TECH TIPS

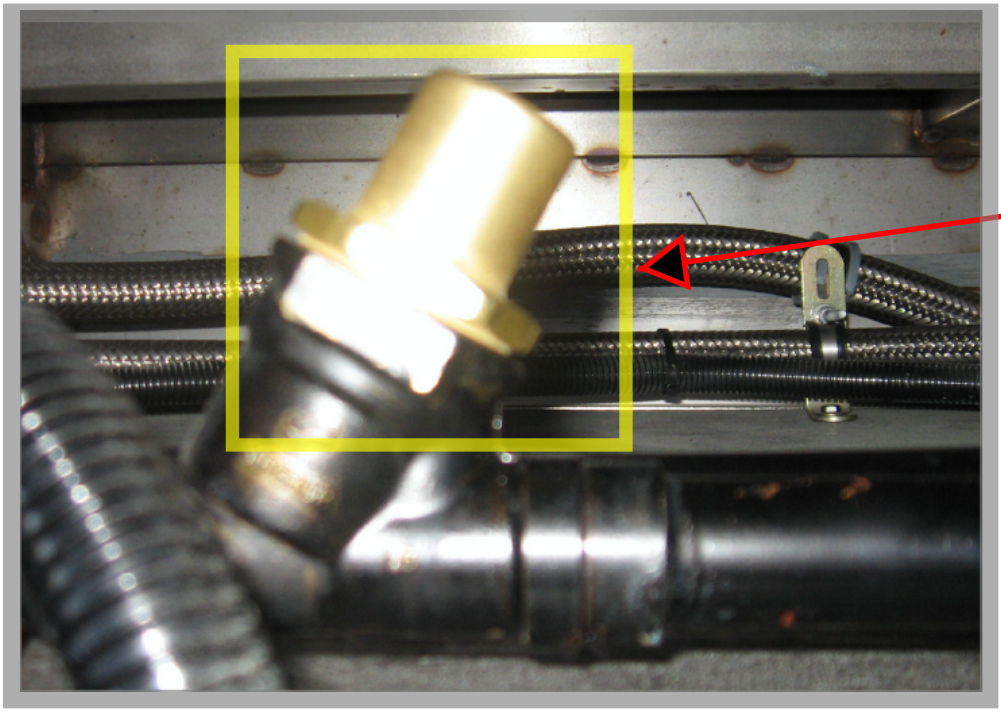
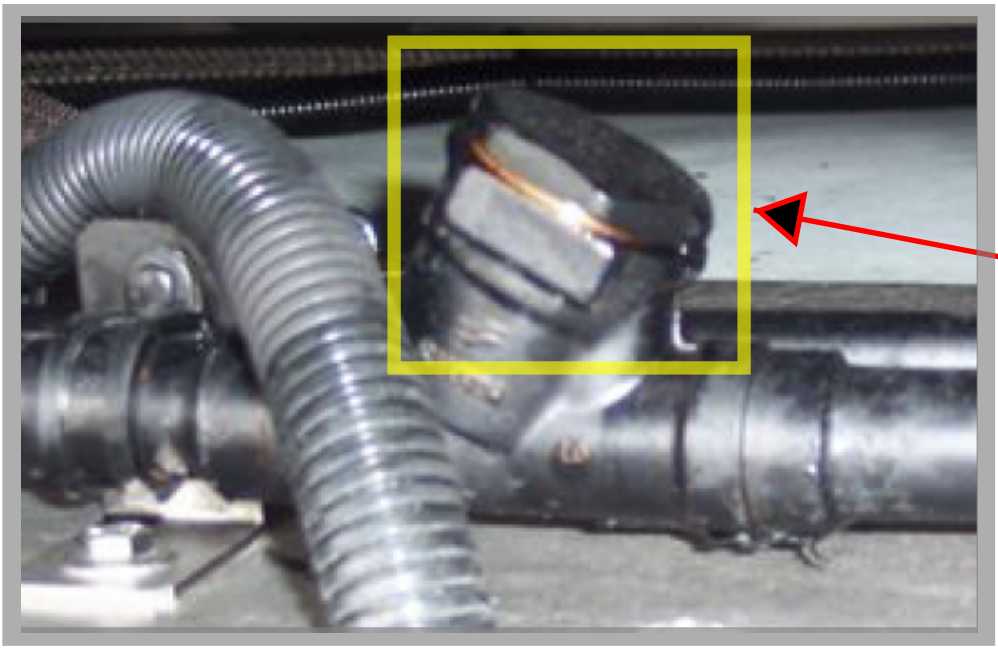
You can ID the new style check valve with the raised center on the cap

The old style has the flat cap

It has been noticed when a C or T coach is in A/C mode and the engine is at regular idle RPM's that the check valve behind the condenser may make a knocking noise. Check the system to verify the correct operating pressures and refrigerant level is ok. If noise still continues ,replacement of the check valve will be necessary

NEW
Part numbers
VH # 11184588
or Carrier #
14-00281-04
